**PIC16F/LF1938/1939
Silicon Errata and Data Sheet Clarification**

The PIC16F/LF1938/1939 family devices that you have received conform functionally to the current Device Data Sheet (DS41364D), except for the anomalies described in this document.

FIGURE 1: INSTRUCTION CYCLE DELAY CALCULATION EXAMPLE

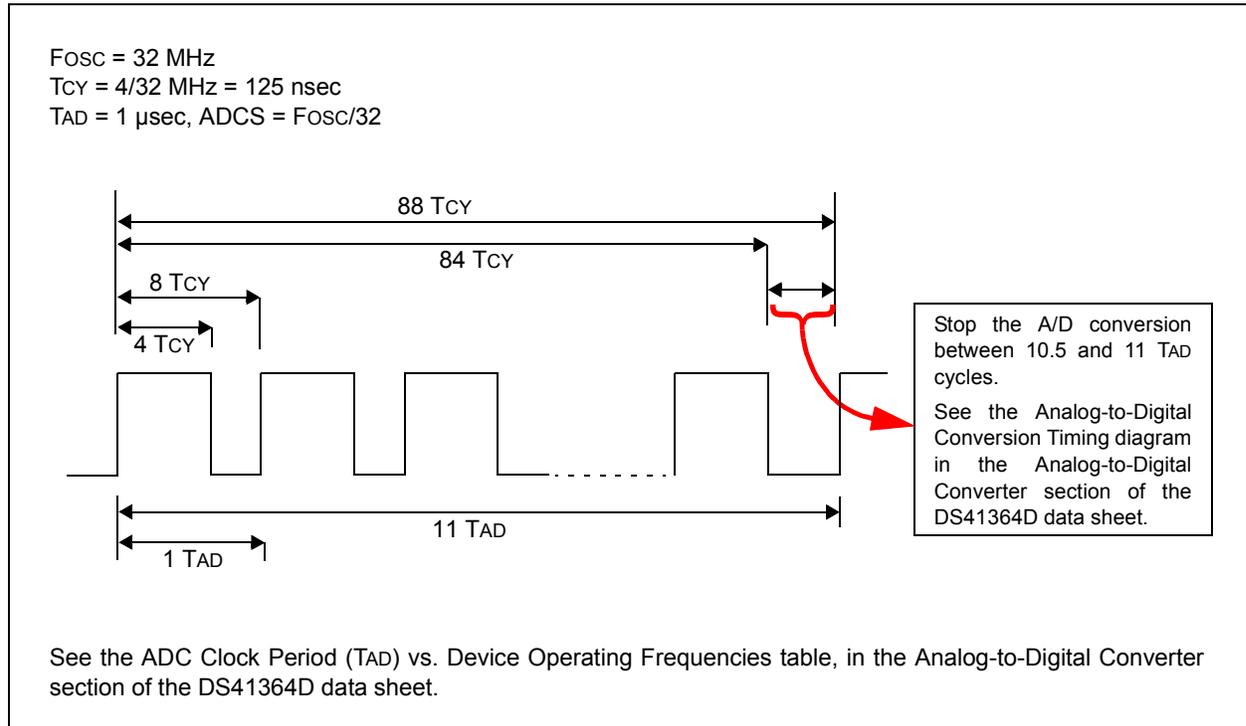
Under certain device operating conditions, the ADC conversion may not complete properly. When this occurs, the ADC Interrupt Flag (ADIF) does not get set, the GO/DONE bit does not get cleared and the conversion result does not get loaded into the ADRESH and ADRESL result registers.

In Figure 1, 88 instruction cycles (Tcy) will be required to complete the full conversion. Each TAD cycle consists of 8 Tcy periods. A fixed delay is provided to stop the A/D conversion after 86 instruction cycles and terminate the conversion at the correct time as shown in the figure above.

Method 2: Provide a fixed delay in software to stop the A-to-D conversion manually, after all 10 bits are converted, but before the conversion would complete automatically. The conversion is stopped by clearing the GO/DONE bit in software. The GO/DONE bit must be cleared during the last 1/2 TAD cycle, before the conversion would have completed automatically. Refer to Figure 1 for details.

Note: The exact delay time will depend on the choice of FOSC and the TAD divisor (ADCS) selection. The TCY counts shown in the timing diagram above apply to this example only. Refer to Table 3 for the required delay counts for other configurations.

FIGURE 29-3: HFINTOSC FREQUENCY ACCURACY OVER DEVICE V_{DD} AND TEMPERATURE

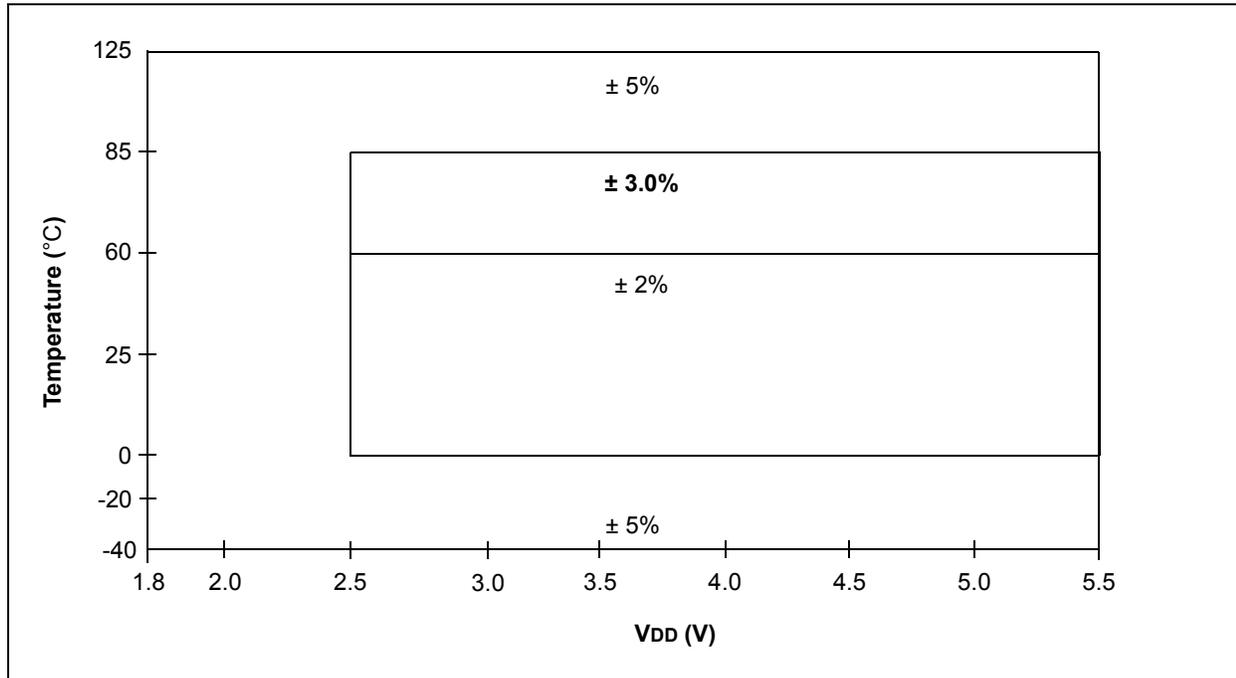
In Figure 29-3, HFINTOSC Frequency Accuracy Over Device V_{DD} and Temperature, the oscillator accuracy should be $\pm 3.0\%$ when V_{DD} is equal to and above 2.5V and when temperatures are equal to and above 60°C, yet still equal to or below 85°C, as shown below.
